LUCAS WORKSHOP INSTRUCTIONS

CONTROL BOXES MODEL RBI06-2**MODIFIED TERMINALS AND ADJUSTING SCREWS**

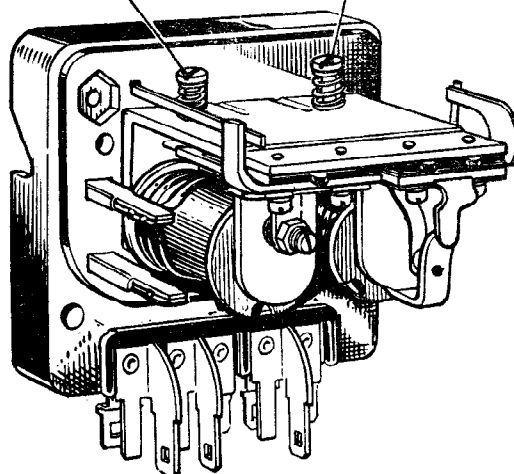
As shown above, "Lucar" terminal blades are being fitted on some units in place of the grub screw type terminals previously employed and shown in Section F-3 Issue 2 Fig. 1.

In addition, the regulator and cut-out electrical settings may be found locked with a compression spring located behind the head of each adjusting screw instead of with a locking nut.
